**SAN ANTONIO WATER COMPANY**  
**ADDENDUM #1**  
**3/6/2019**  
**(Sheet 1)**

RESERVOIR NO. 7 IMPROVEMENT PROJECT - CO#1701-A

**CHANGE IN CONTRACT DOCUMENTS / NOTICE TO BIDDERS**

'REVISED'  
"ALL CORNERS"  
CONSTRUCTION JOINT SECTION

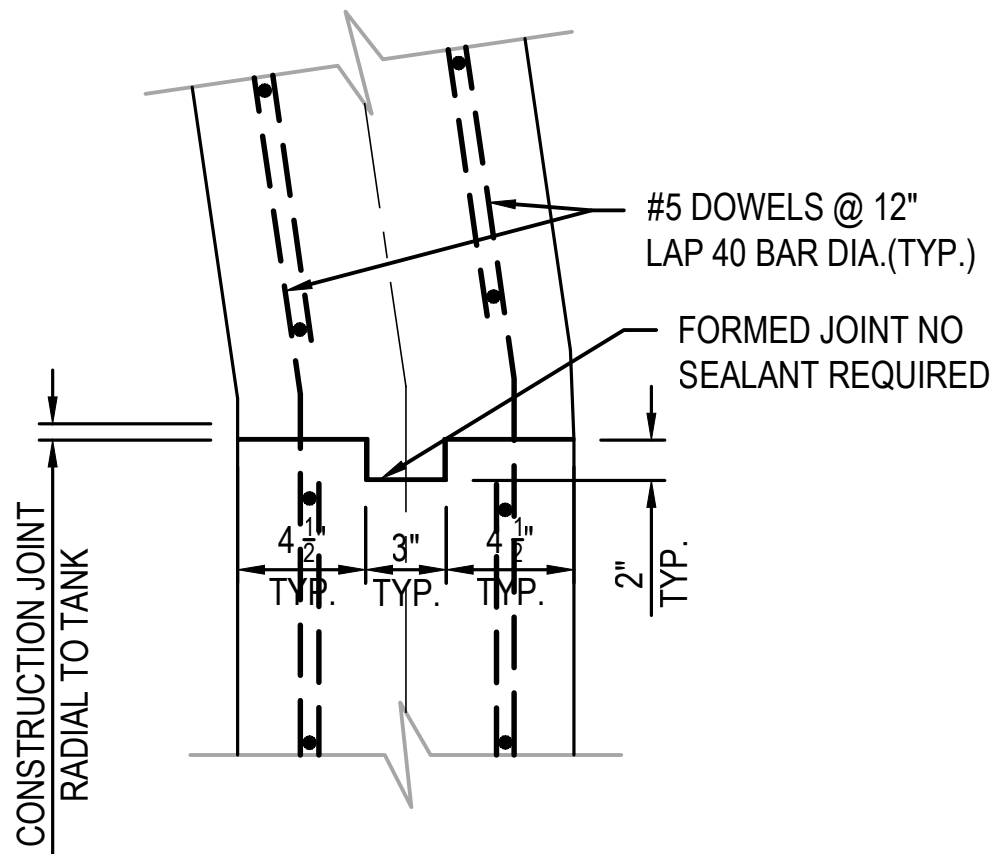
1. See attached list of questions provided by bidders and answers.
2. See attached revised detail for construction joint Detail H sheet 3.
3. See attached specification section 09900 for painting and coating of exposed steel piping, valves and fittings.
4. See Attached revised piping detail for the offsite installation of the control valve. All piping and fittings shall be schedule 40 steel ML&C or ML&P as shown.

Q 15: Construction Joint Detail H/Sheet 3. Please clarify dimensions of construction joint. The detail shows the joint tapering from water side to exterior but no dimensions are provided. Is sealant required in this joint? If so, please specify type.

A: See revised key type construction joint detail attached for clarification. No sealant is required, construct the joint radially to the reservoir, no taper is required.

**OFF-SITE PIPING AND CONCRETE VAULT PLAN**

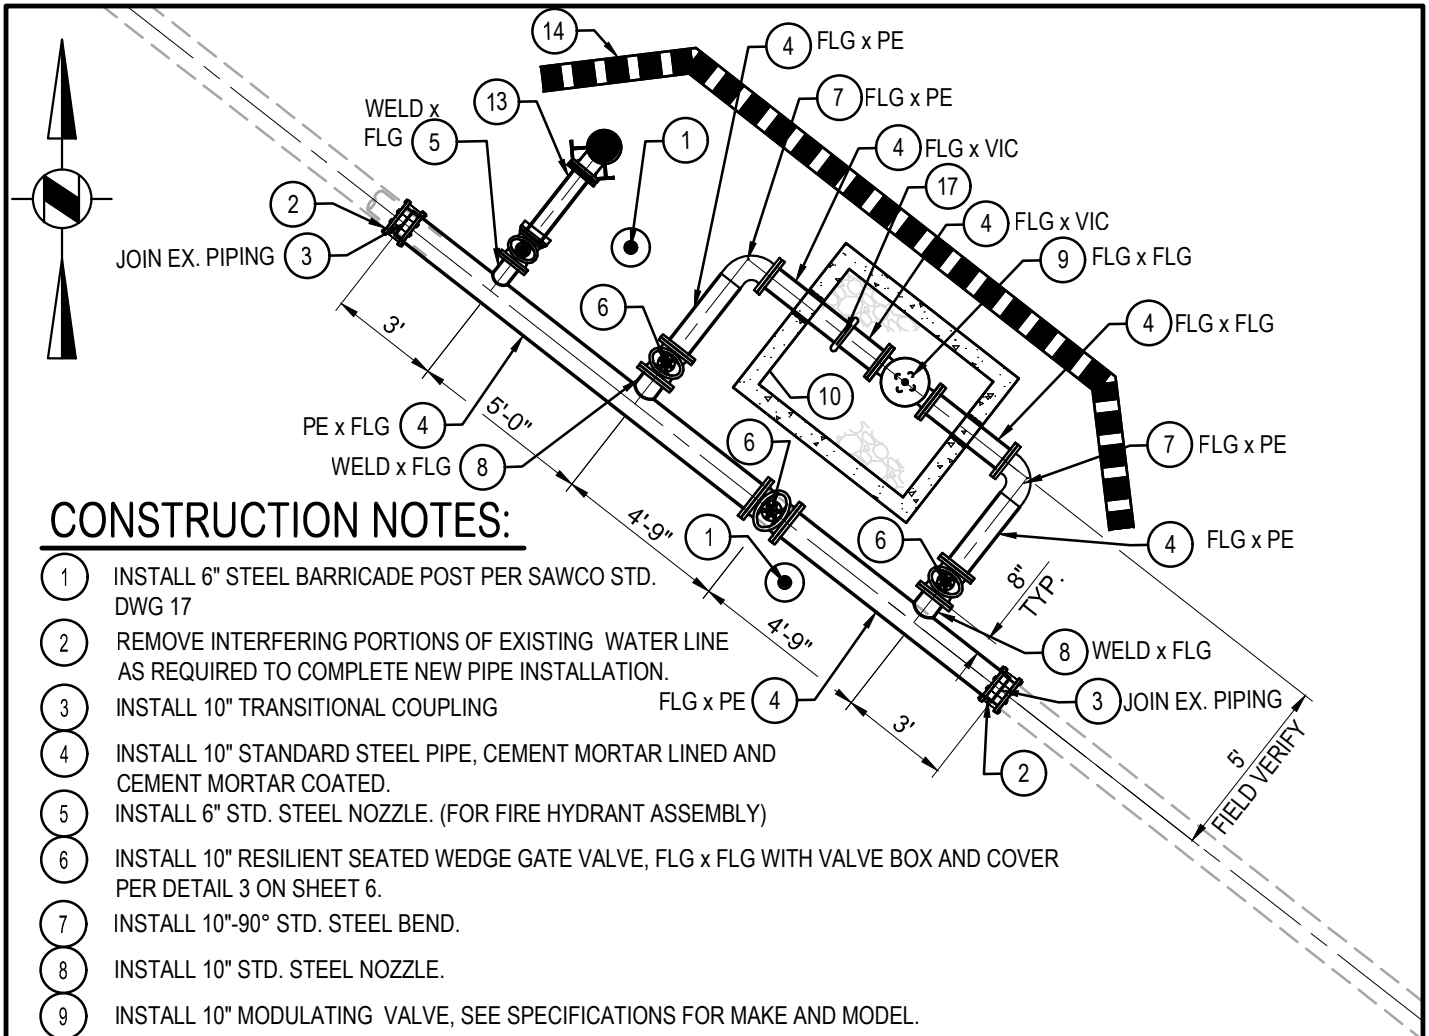
Q 17: The drawing notes on sheet 5 of 6 call for CML&C steel piping and also for ductile iron MJ fittings, of course those fittings are not compatible with steel pipe. What material is preferred for the fittings?

A: All pipe and fittings are to be schedule 40 Steel CML&C or CML&P per the attached revised detail and construction notes.

- 1 INSTALL 6" STEEL BARRICADE POST PER SAWCO STD. DWG 17
- 2 REMOVE INTERFERING PORTIONS OF EXISTING WATER LINE AS REQUIRED TO COMPLETE NEW PIPE INSTALLATION.

- 3 INSTALL 10" TRANSITIONAL COUPLING
- 4 INSTALL 10" STANDARD STEEL PIPE, CEMENT MORTAR LINED AND CEMENT MORTAR COATED.
- 5 INSTALL 6" STD. STEEL NOZZLE. (FOR FIRE HYDRANT ASSEMBLY)

- 6 INSTALL 10" RESILIENT SEATED WEDGE GATE VALVE, FLG x FLG WITH VALVE BOX AND COVER PER DETAIL 3 ON SHEET 6.
- 7 INSTALL 10"-90° STD. STEEL BEND.
- 8 INSTALL 10" STD. STEEL NOZZLE.

- 9 INSTALL 10" MODULATING VALVE, SEE SPECIFICATIONS FOR MAKE AND MODEL.
- 10 INSTALL PRECAST CONCRETE VAULT PER DETAIL HEREON, SEE SPECIFICATIONS FOR MAKE AND MODEL.

- 11 3/4" GRAVEL, 12" DEEP OVER COMPACT NATIVE MATERIAL TO 90% RELATIVE DENSITY.
- 12 INSTALL NON-SHRINK, GROUT, SEAL ANNULAR OPENINGS AS REQUIRED.
- 13 INSTALL 6" FIRE HYDRANT ASSEMBLY PER SAWCO STD. DWG. 15.

- 14 CONSTRUCT CONCRETE BLOCK SLOUGH WALL PER SAN BERNARDINO COUNTY STD. DWG. 301a.
- 15 INSTALL ADJUSTABLE PIPE SUPPORT PER DETAIL 4 ON SHEET 6.
- 16 NOT USED.

- 17 INSTALL 10" VICTAULIC COUPLING, STYLE 77 OR EQUAL.
